Re: Second Submission Review – Green Valley Ranch East Site Plan No. 15 - Site Plan and Plat

Application Number: **DA-1662-26**

Case Number(s): 2022-4014-00; 2022-3019-00

GREEN VALLEY RANCH EAST SITE PLAN #15

p:\oakwood master folder\gvr east-current\1_filing 15\cad\submittals\gvr f.15 site plan\1.1-sheets\1.15 individual irrigation rebates.dwg

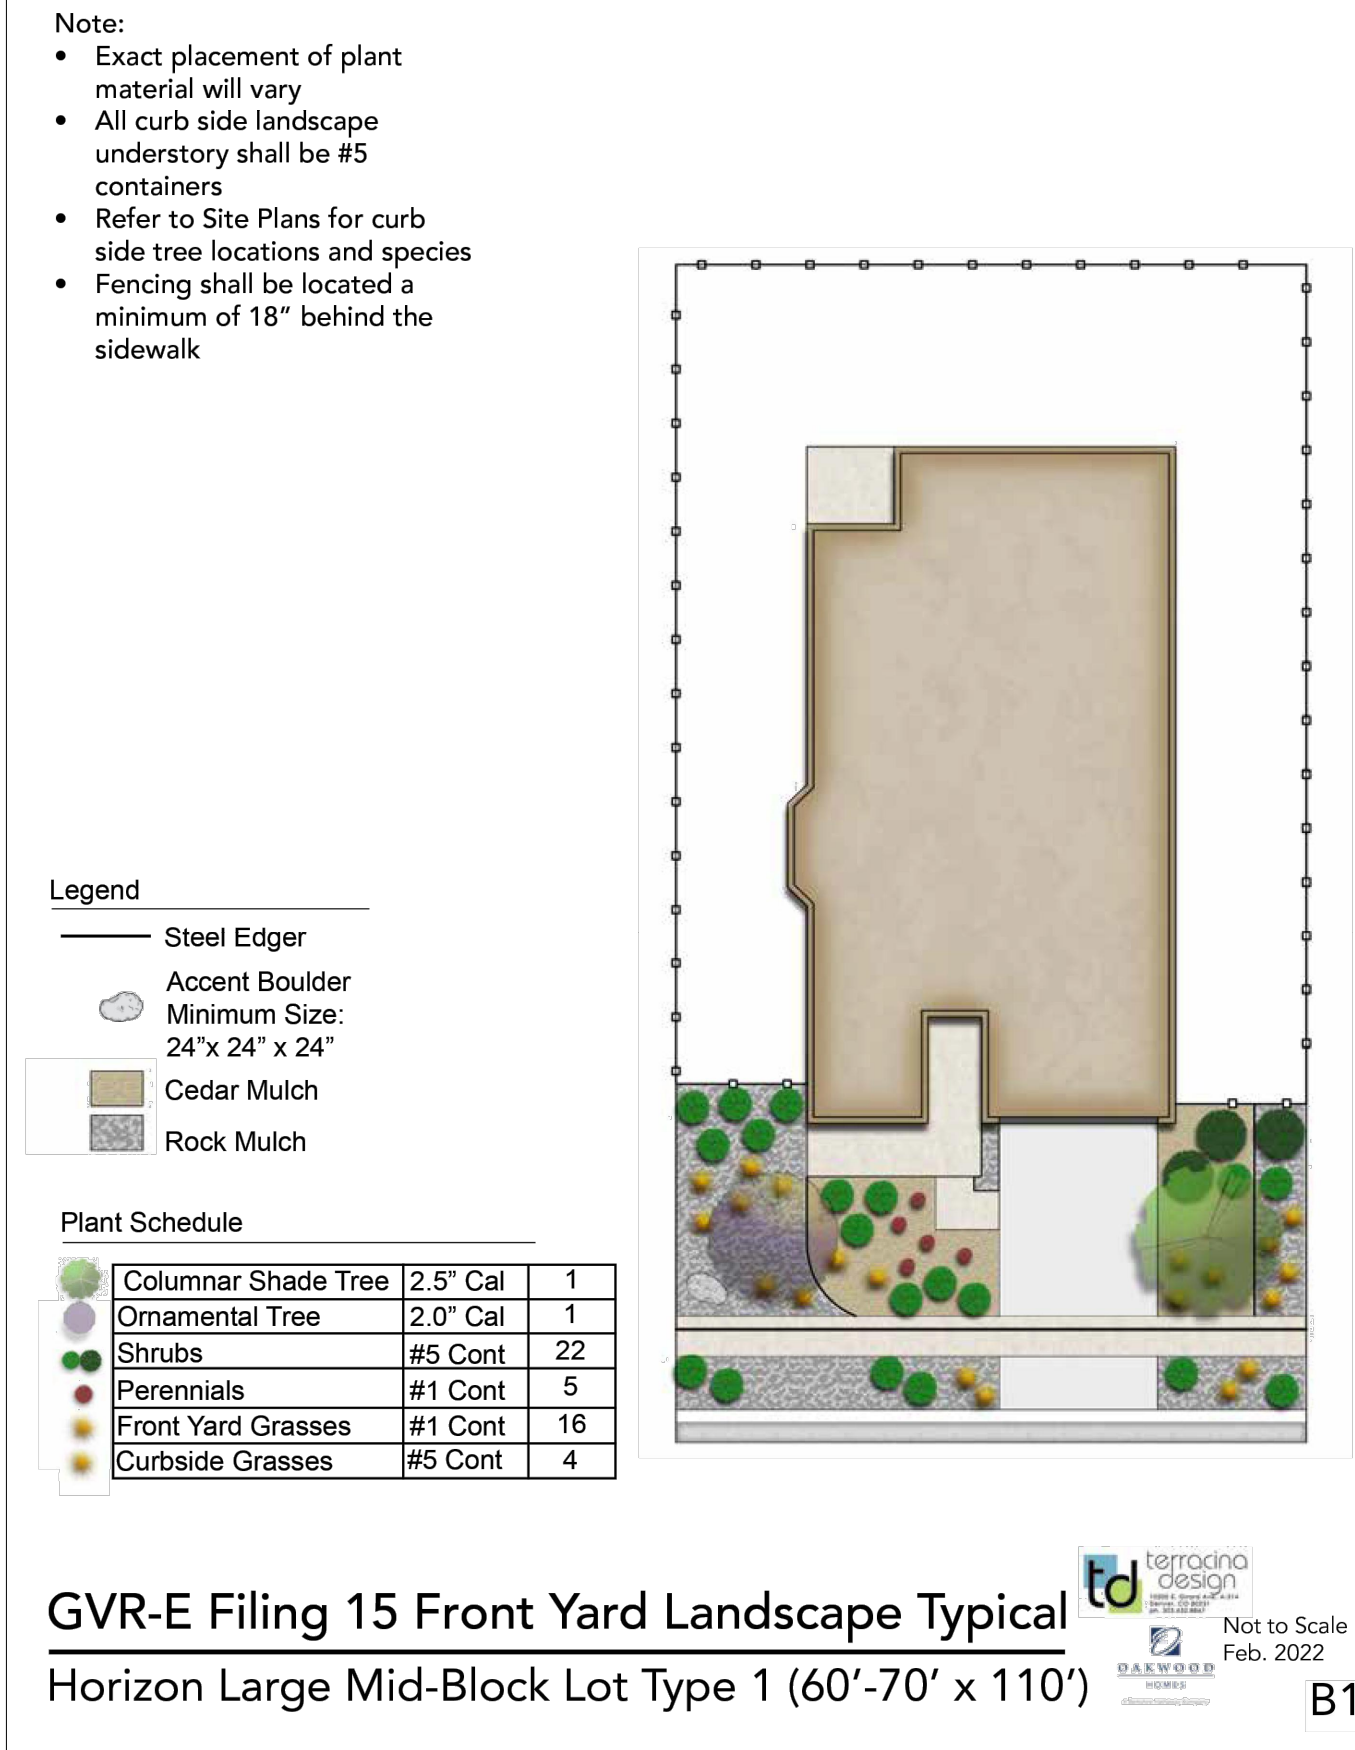
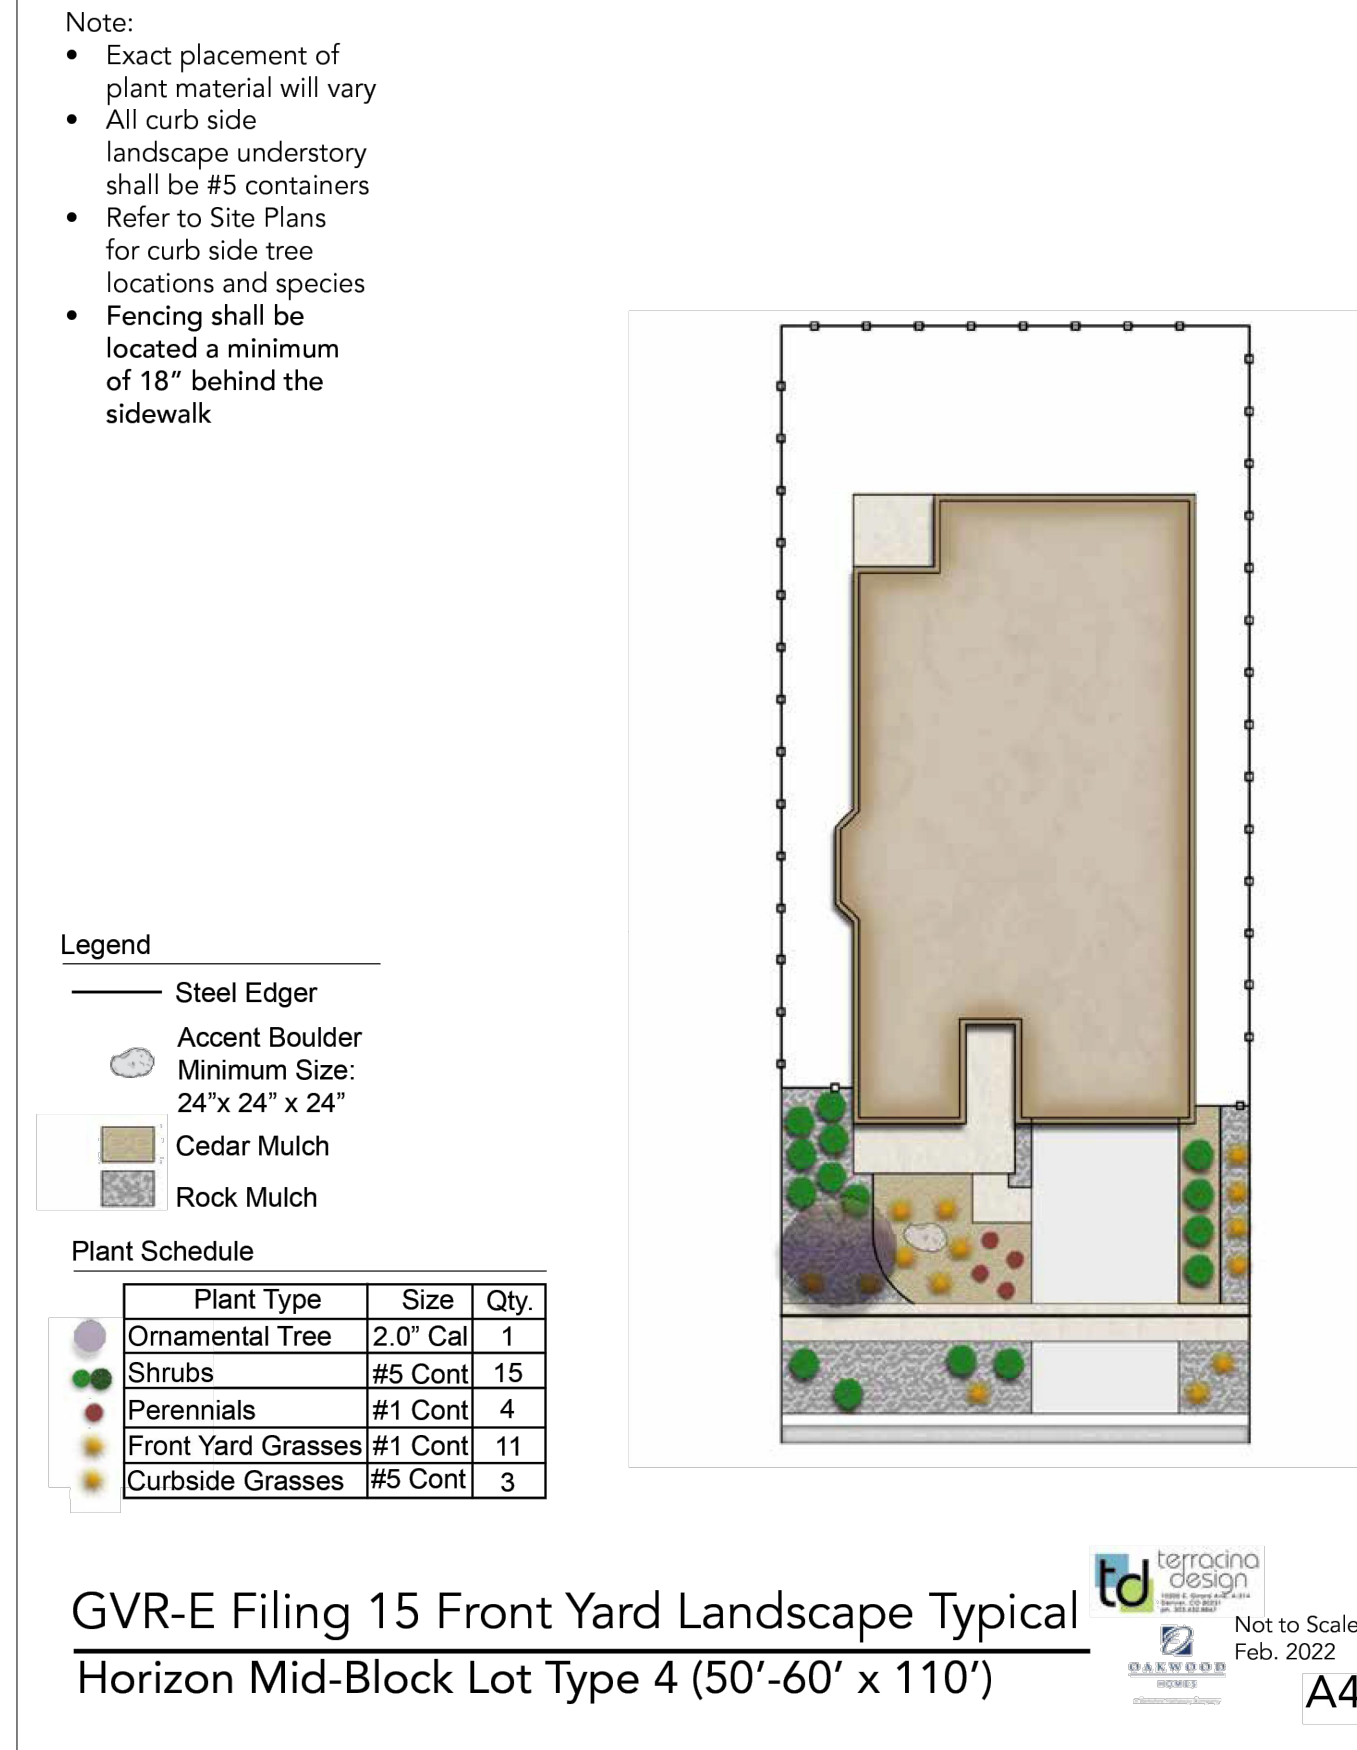
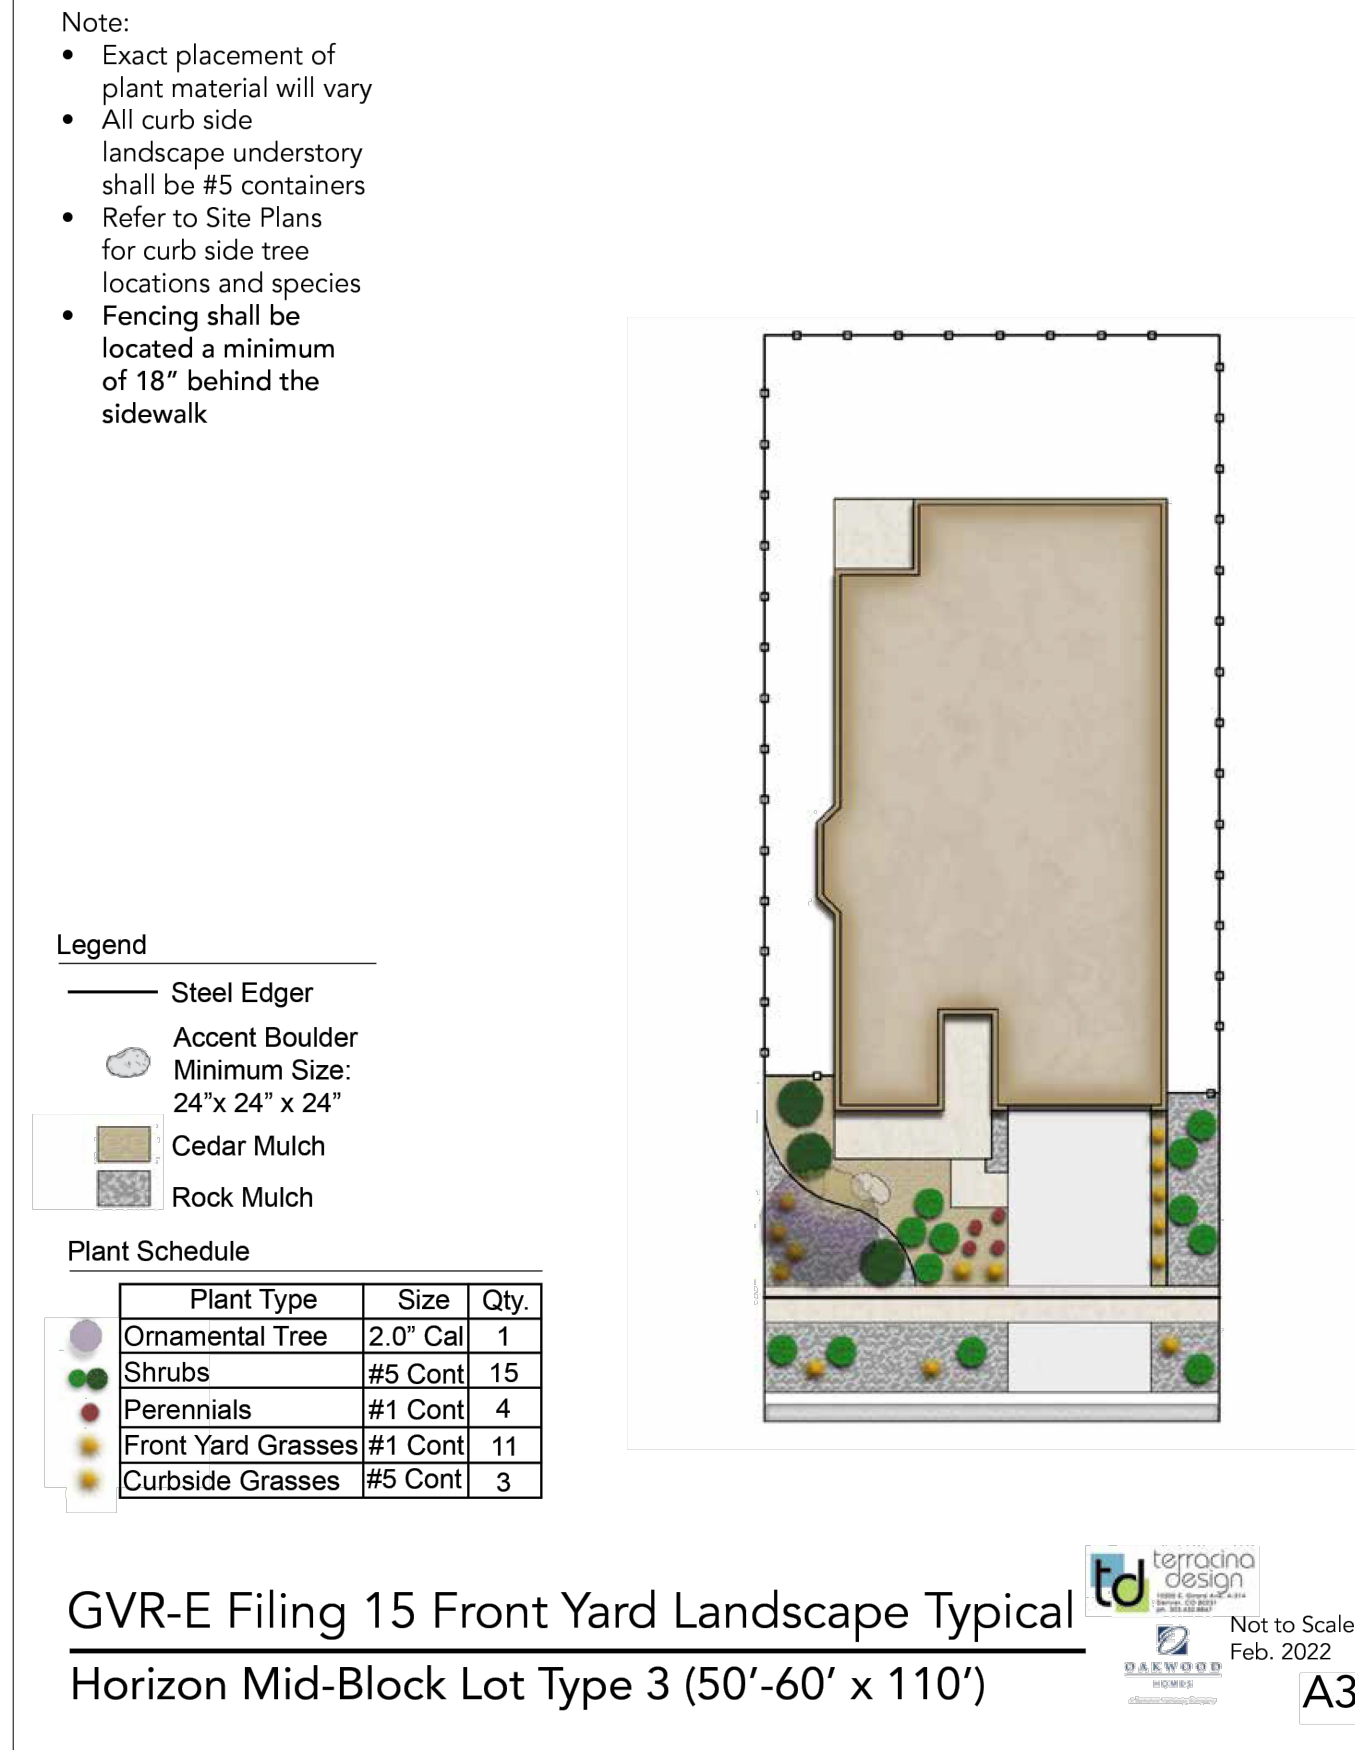
Doesn't match location or size of lots
